# Access Compliance Report

## Public Rights-of-Way

Intersection ID: 27245	Main Street: ELMSTONE_DR	Cross Street: THORNCREST_RD	Location: S
ADA ID: B1E5825642A3	Ramp Type: PerpDiag	Initial Pass/Fail: Fail	Overall Compliance: No
		Severity Score: 25

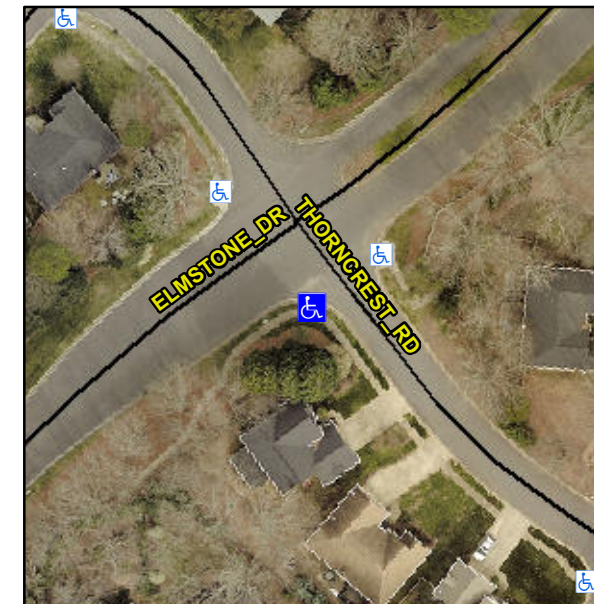
**Not Found, R304.2.2, R304.5.3**

Compliance	Description	Data	Compliance	Description	Data
N/A	Ramp Length (in)	36.0	No	Ramp Slope (%)	8.7
Yes	Ramp Width (in)	48.0	No	Ramp XSlope (%)	5.6
N/A	Flare Type LT	N/A	N/A	Flare Type RT	N/A
N/A	Flare Slope LT (%)	N/A	N/A	Flare Slope RT (%)	N/A
N/A	Flare Traversable LT?	N/A	N/A	Flare Traversable RT?	N/A
N/A	Landing Length (in)	N/A	N/A	DWS Provided?	N/A
N/A	Landing Width (in)	N/A	N/A	DWS Contrast?	N/A
N/A	Landing Slope (%)	N/A	N/A	DWS Length (in)	N/A
N/A	Landing X Slope (%)	N/A	N/A	DWS Full Width?	N/A
N/A	Landing Curb? (Y/N)	N/A	N/A	DWS Offset (in)	N/A
N/A	Shared Landing?	N/A			
N/A	Gutter Ponding?	N/A	N/A	Gutter Slope (%)	N/A
N/A	Gutter Lip Ht (in)	N/A	N/A	Gutter X Slope (%)	N/A
N/A	Painted X Walk1?	No	N/A	Painted X Walk2?	No
	X Walk 1 Direction	To NE		X Walk 2 Direction	To NW
N/A	X Walk 1 Width (in)	N/A	N/A	X Walk 2 Width (in)	N/A
	X Walk 1 Slope (%)	4.7		X Walk 2 Slope (%)	4.5
	X Walk 1 X Slope (%)	5.0		X Walk 2 X Slope (%)	2.1

**Remove & Replace Curb Ramp With Two New Directional Ramps or Equivalent.**
